BRADFORD CITY No. 5 DAM
(TUNA CREEK DAM)

NDI No. PA 00026
PennDER No. 42-31

PHASE I INSPECTION REPORT
NATIONAL DAM INSPECTION PROGRAM

MICHAEL BAKER, JR., INC.

FIELD SKETCH

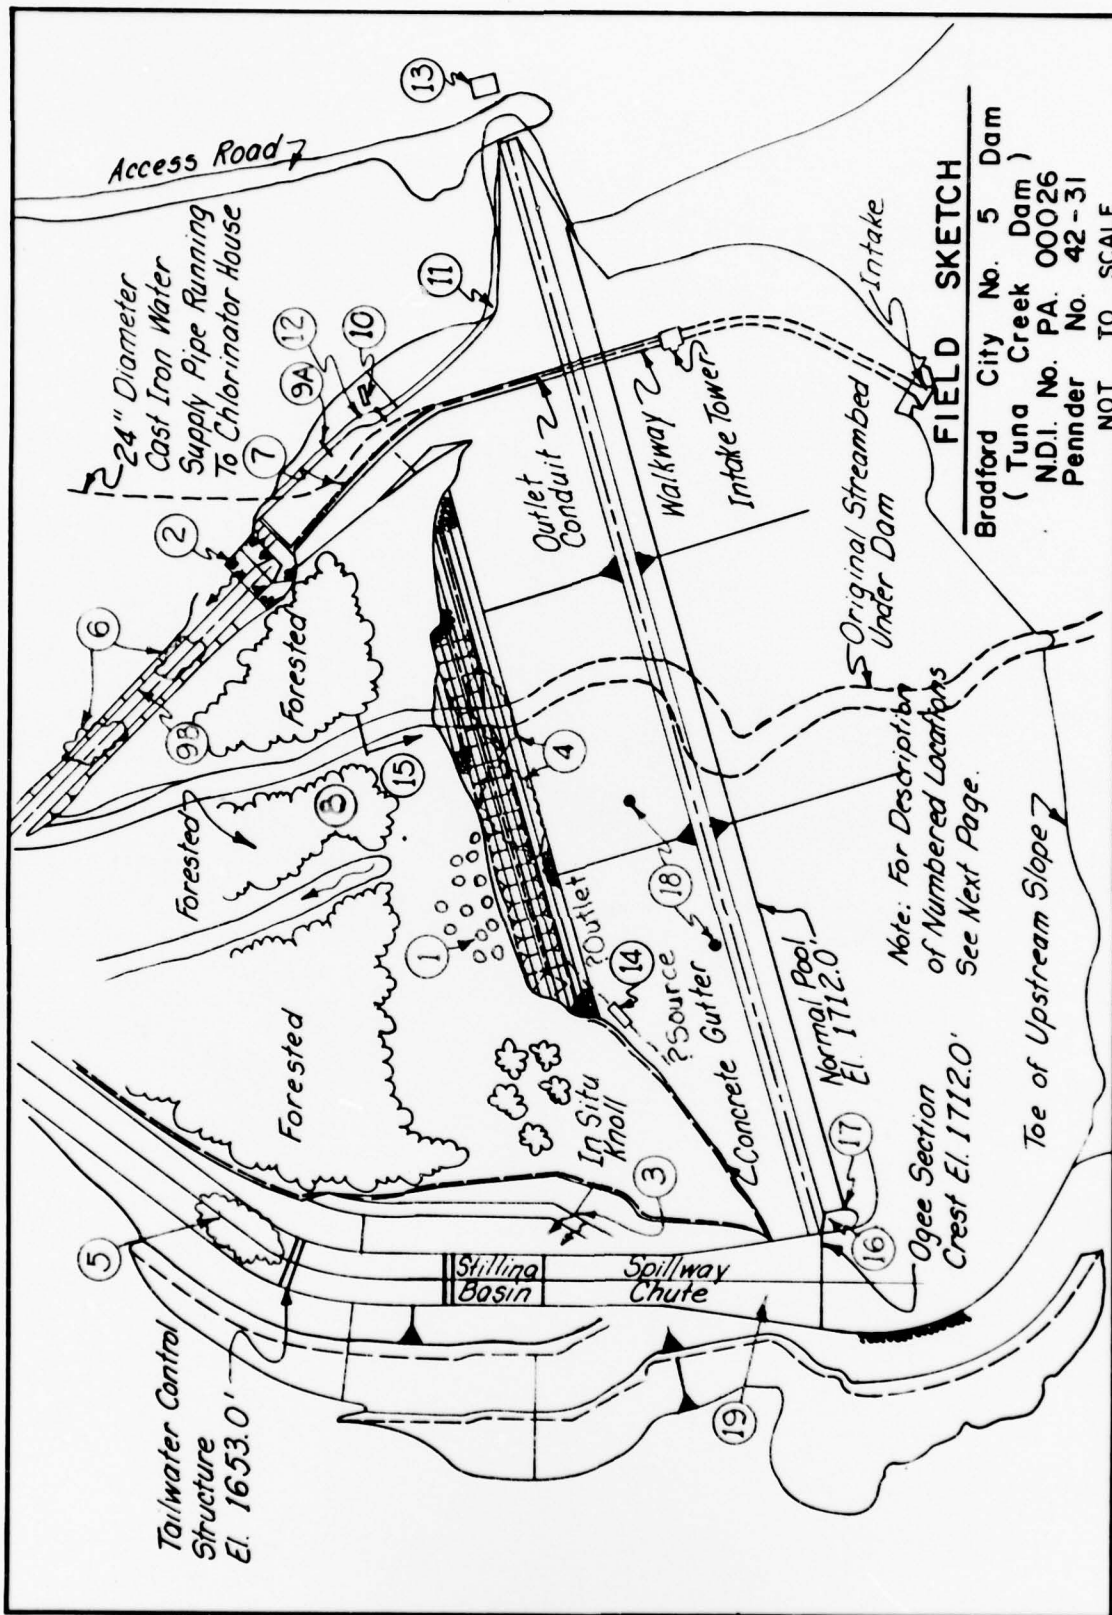
- a. Visual Observations - The cause of the vertical holes downstream of the rock toe drain should be determined by a detailed investigation in this area. The investigation should develop recommendations for the remedial work which will be necessary to correct the cause of these holes and repair the area. These holes and the probable cause or causes (see paragraph 3.1.b.) are not considered adverse to the structural stability and safety of the dam at the present time. However, the investigation should include the inspection of the 4 inch clay tile drainpipe located in the area and the cause of the observed seepage exiting the ground surface (item 8 on the field sketch) 200 feet downstream from the area.

The observed seepage exiting from the in situ knoll (item 3 on the field sketch) should be periodically examined in the future to verify that the quantity of seepage is not increasing and transportation of fine material is not occurring. Should the extent of the seepage significantly increase with time, the condition should be studied in detail and appropriate remedial measures taken.

The seepage exiting from behind the right wing wall of the outlet conduit structure (item 2 on the field sketch) should be examined frequently in the future to verify that the quantity of seepage is not increasing and transportation of fine material is not occurring. A seepage weir should be installed to monitor the rate of flow. The turbidity of the flow should also be measured and recorded. It is recommended that the outlet pipe for the catch basin adjacent to the access road on the right abutment be repaired and the discharge outletted downstream from the head wall. Additionally, it is recommended that the concrete gutter, or possibly a pipe, (item 11 of the field sketch) on the right side of the dam be extended to discharge downstream from the outlet head wall. Should the extent of the seepage area or characteristics of the seepage increase with time, the condition should be studied in detail and appropriate remedial measures taken.

1. Numerous holes below toe of dam. Most of the holes are approximately 2 feet by 2 feet in plan view and 18 inches deep. However, one hole was at least 6 feet deep. Water was standing in a few of the deeper holes approximately 1 to 2 feet below the ground surface.

- 1) The owner should have a qualified professional engineer investigate, in detail, the cause of the vertical holes downstream from the toe drain of the embankment. Also, the condition of the 4 inch tile drain and the cause of the seepage exiting near this area should be evaluated as a part of the investigation.

- 2) Periodically examine the seepage exiting from the left side of the in situ knoll near the spillway chute channel. Should the quantity of seepage or turbidity significantly increase with time, the condition should be studied in detail and appropriate remedial measures taken.

- 3) Install a seepage weir to monitor the rate of flow from behind the right wing wall of the outlet conduit head wall structure. This weir should be checked frequently for rate of flow and turbidity, and the measurements should be recorded. If the results of the measurements indicate a change in quantity or turbidity of the flow, appropriate action should be taken.
